SERVICE BULLETIN

from: TRIO-KENWOOD COMMUNICATIONS, INC.

58

SUBJECT: TR-2400 Tone Encoder RFI

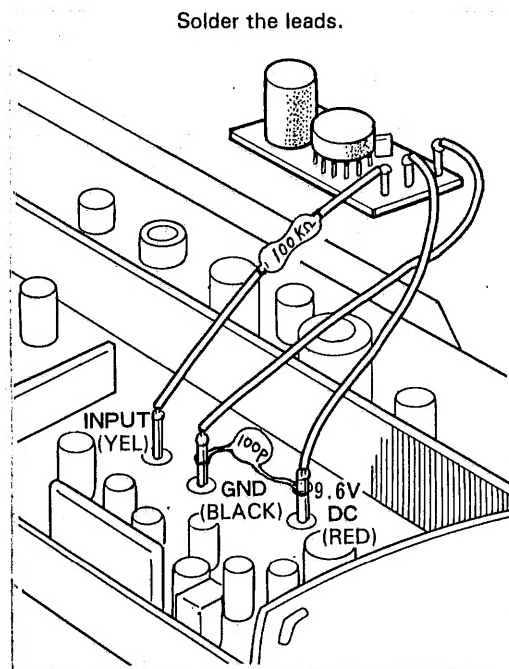
In some cases, users may report RF interference, or motor-boating, when using a Tone encoder in their TR-2400. A secondary complaint of excessive tone may also be encountered.

1. For RFI, bypass the B+ terminal to ground with a 100 μ F cap.
2. For excessive tone input to the TR-2400, install a 100K ohm resistor between the encoder and the TR-2400 Tone input terminal.
